EASTERN CORRIDOR SEGMENTS II AND III (PID 86462)

COMBINED LINWOOD/EASTERN INTERCHANGE & US 50/RED BANK INTERCHANGE FOCUS AREAS ADVISORY COMMITTEE MEETING NOTES

February 14, 2018
May 22, 2018
September 7, 2018
December 12, 2018

Figure I-29A
**ROUNDBOUT AT BEECHMONT AVENUE
AND LINWOOD AVENUE INTERSECTION**

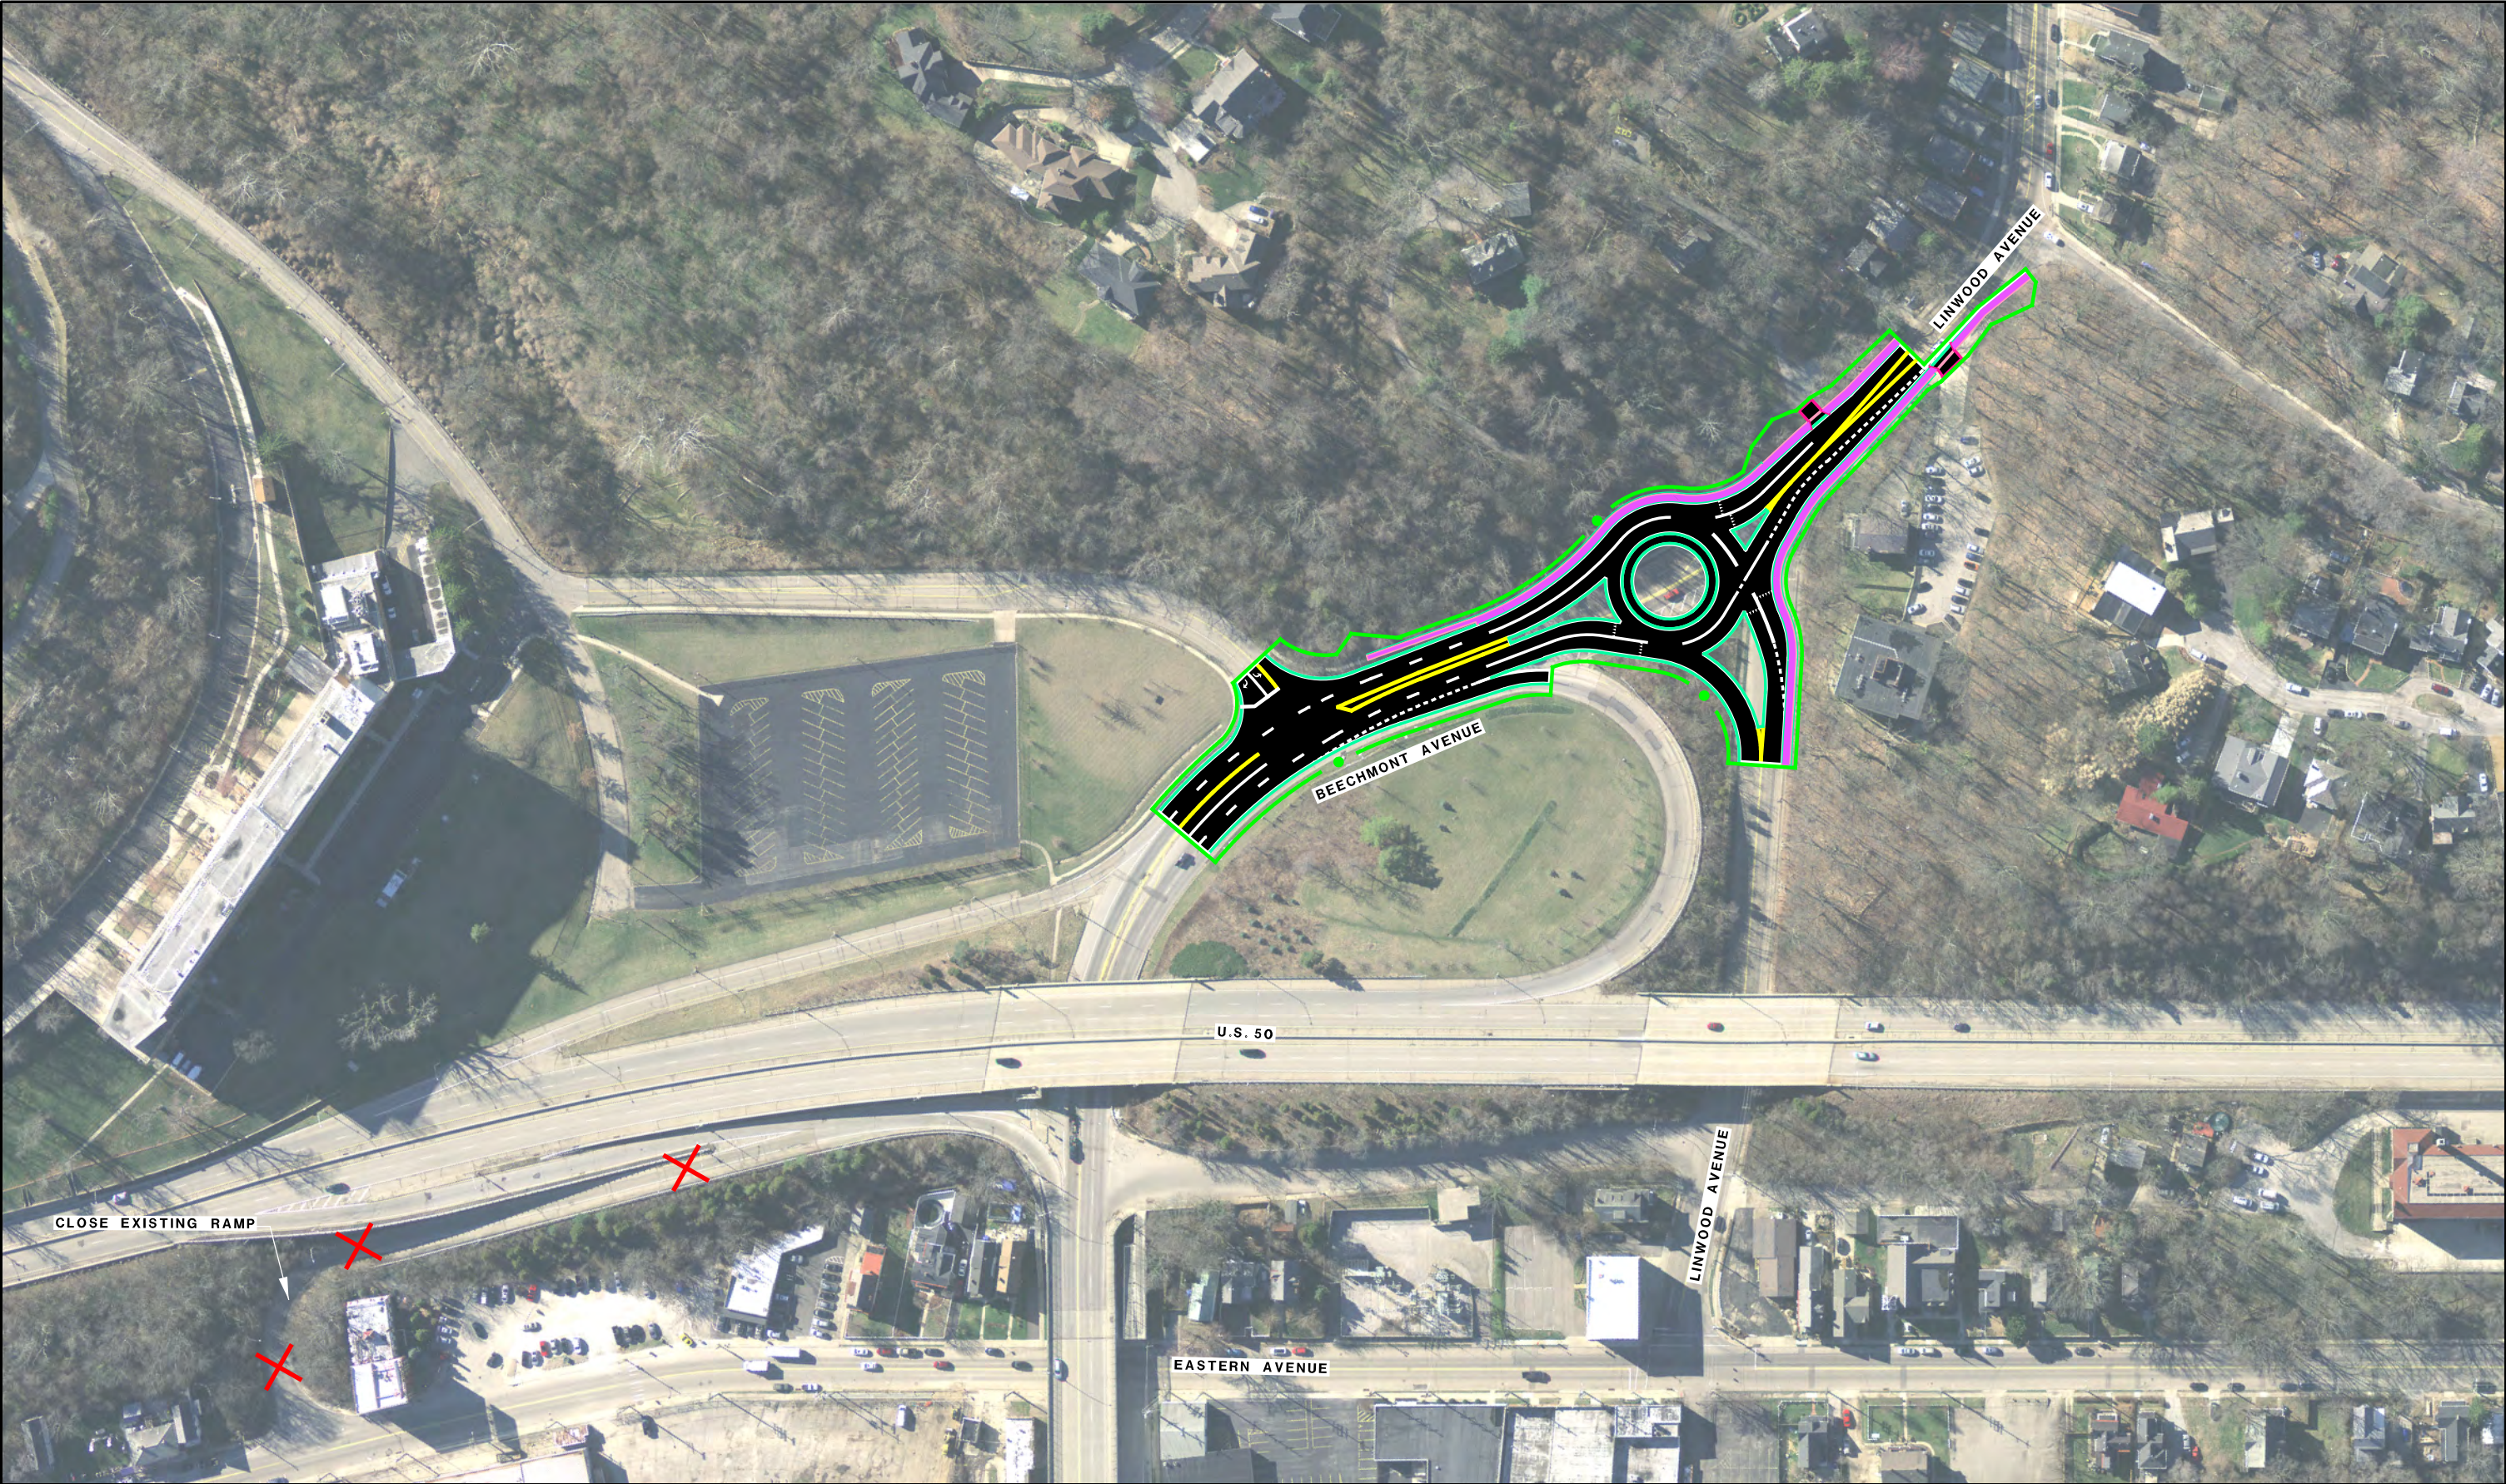
- Roundabouts can serve as gateways to communities or neighborhoods. They also slow traffic while allowing it to flow continuously.
- Initial analysis indicates this concept works well:
 - 50 percent decrease in evening peak-hour delays.
 - Neutral for morning peak-hour delays (still LOS A/B)
- A roundabout at this location would provide a better neighborhood connection to Armleder.
- Pedestrian access across a two-lane roundabout is challenging, but this is not identified as a high-pedestrian area.
- The sight distance approaching the proposed roundabout is shorter than desired.
- Need to determine if a signalized intersection would work better at this location (See concept I-29b)
- No additional comments received following the 5/22 meeting.

- The roundabout is significantly (nearly 10 times) more costly than the signalized alternative (I-29b), which also works well to improve delays. However, roundabouts provide other safety benefits, such as slowing traffic as it enters the Mt. Lookout neighborhood.

- The City of Cincinnati stated that this concept does not meet purpose and need for Beechmont (improve poor connectivity); it also does not have the funding for implementation. Therefore, while the City is not rejecting the proposed projects at this time, it is not endorsing them either. ODOT noted that the work being completed at this time is a planning-level effort; projects included in the Implementation Plan will be available for future planning purposes. The Implementation Plan includes projects that are known at this time; other projects identified in the future could be considered in their place following the requisite public involvement.

- Include concept in the Implementation Plan as a low priority.

Figure I-29B & X-3B
CLOSURE OF GEOMETRICALLY DEFICIENT RAMP FROM
EASTERN AVE TO S.R. 125 AND REPLACEMENT WITH
INTERSECTION AT LINWOOD AVENUE

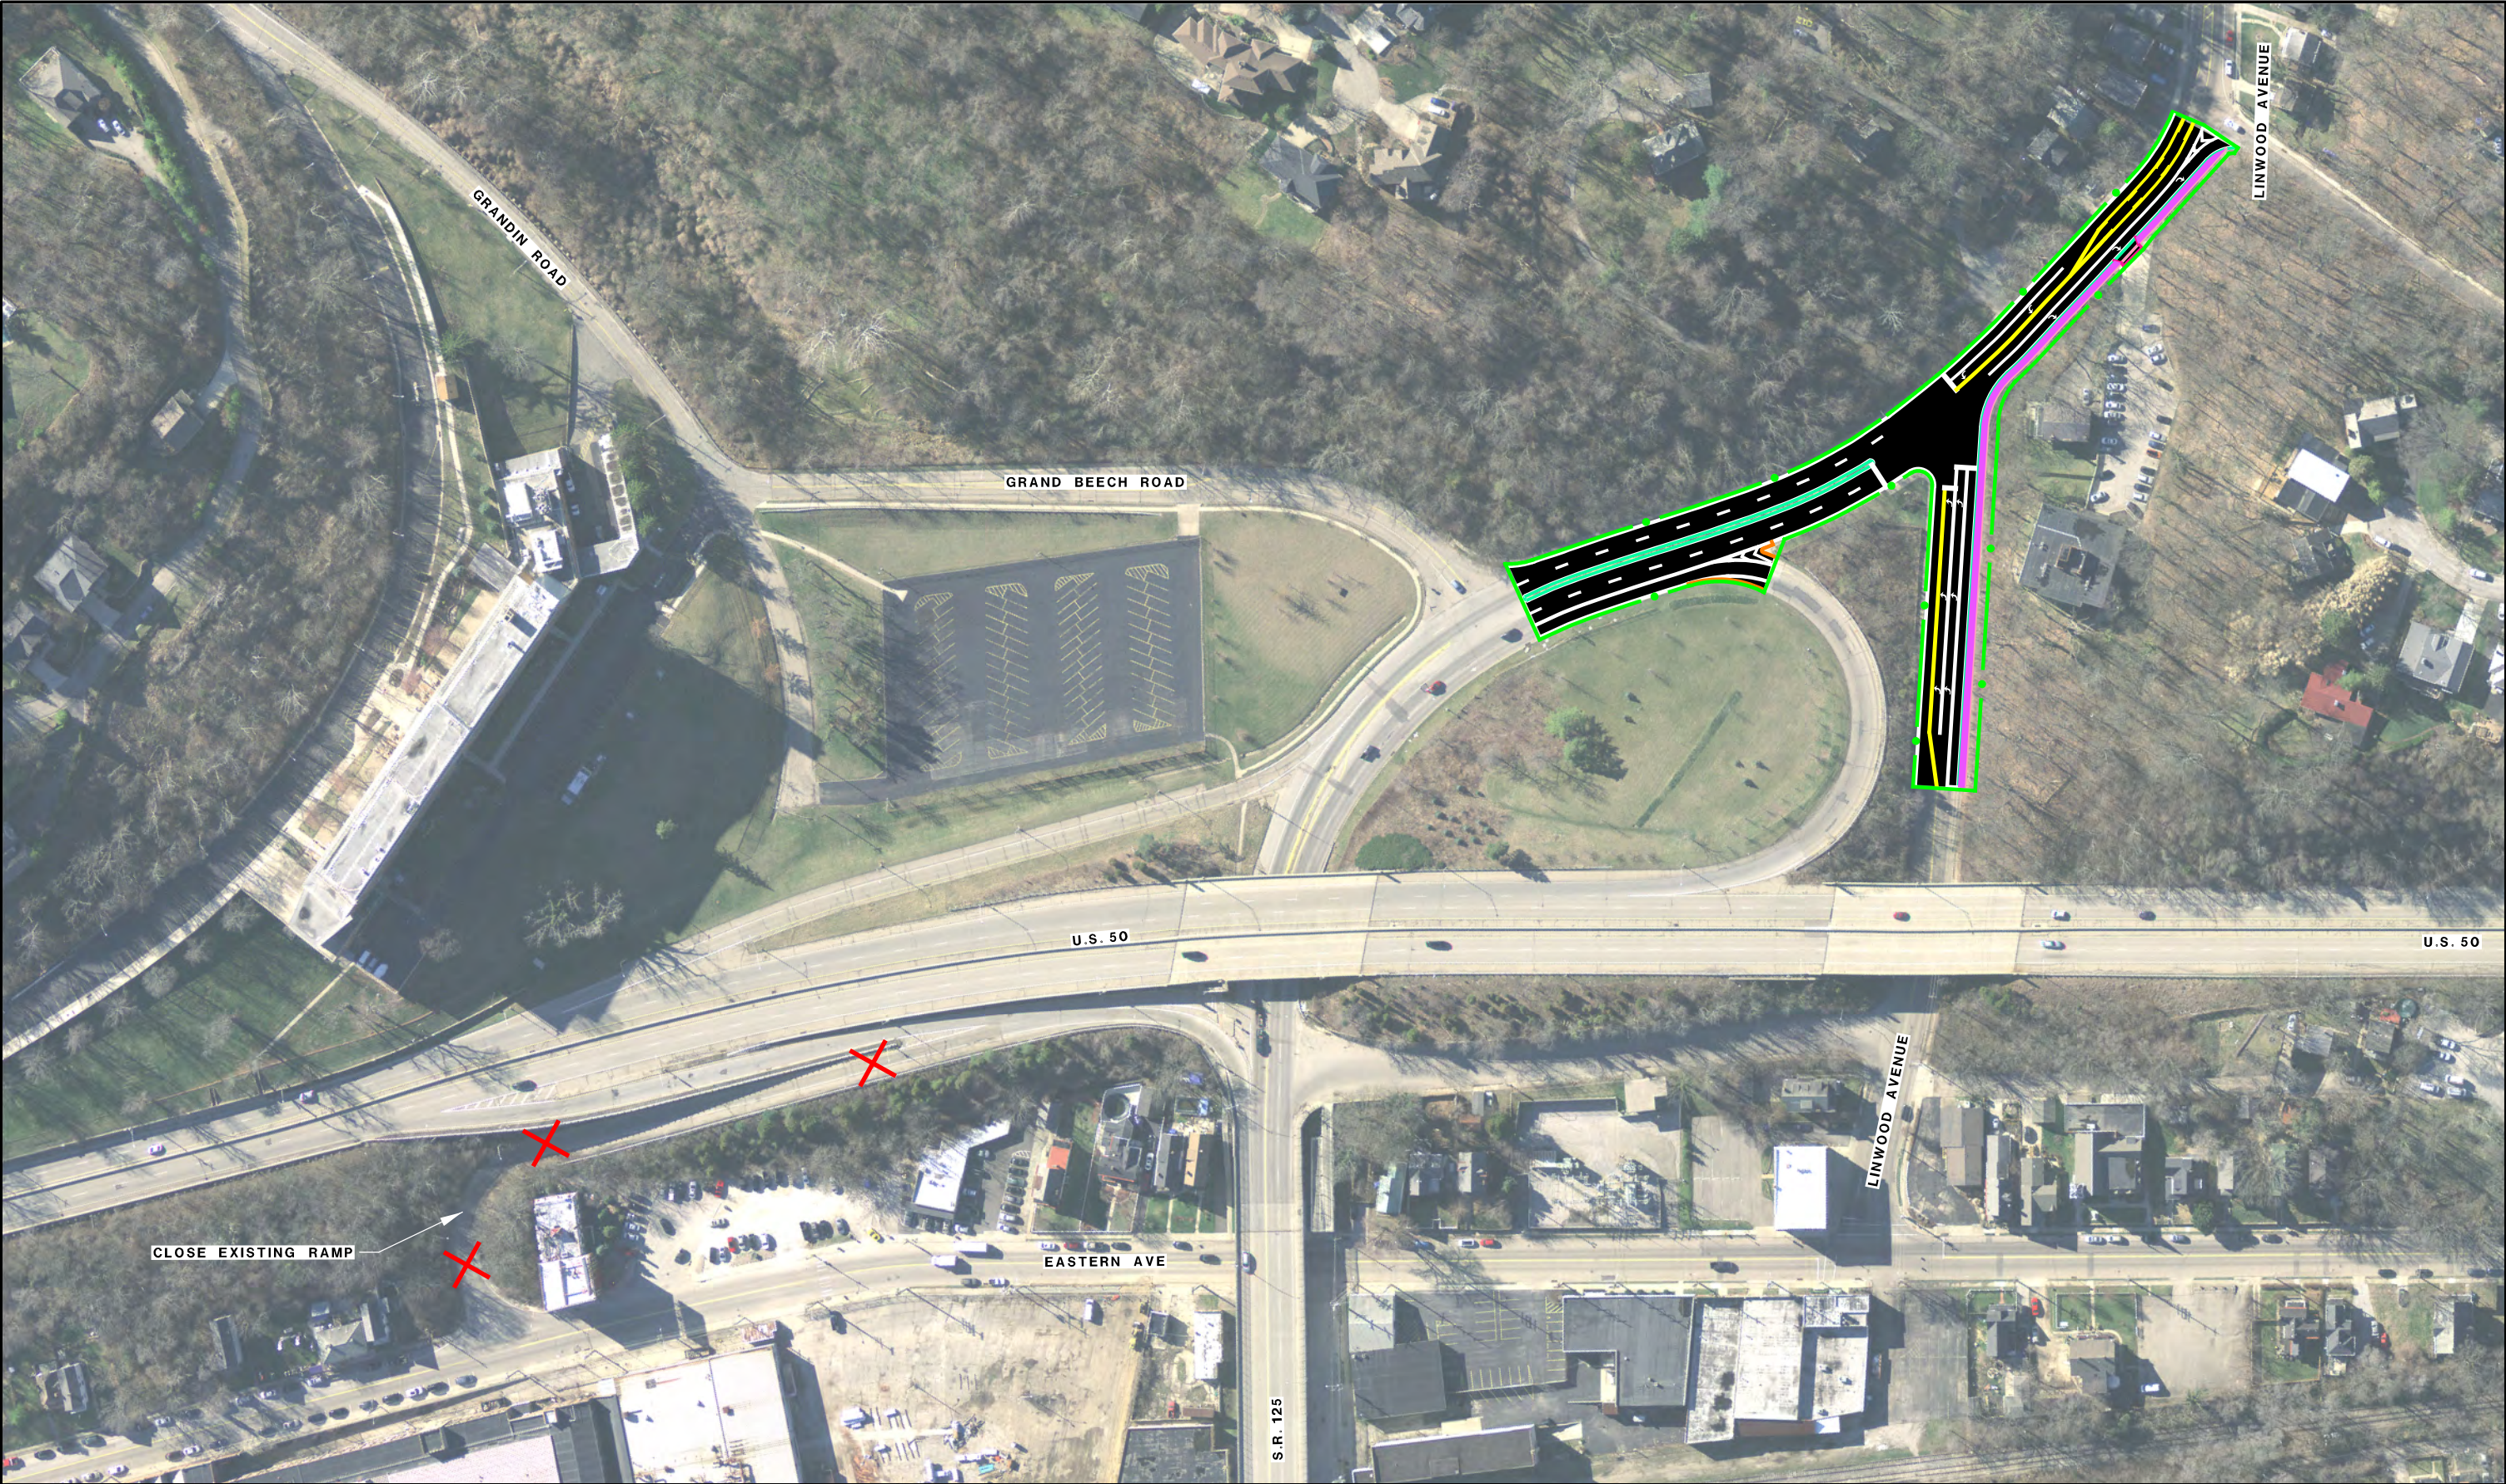
- The City emphasized that it cannot improve connections between US 50 and SR 125 without improving connections within the neighborhoods. Therefore, the ramp in question would not be closed unless another suitable option were available. Because this project would be located within City limits, the City would have jurisdiction over this project.

funding for implementation. Therefore, while the City is not rejecting the proposed projects at this time, it is not endorsing them either. ODOT noted that the work being completed at this time is a planning-level effort; projects included in the Implementation Plan will be available for future planning purposes. The Implementation Plan includes projects that are known at this time; other projects identified in the future could be considered in their place following the requisite public involvement.

- Include concept in the Implementation Plan as a low priority.
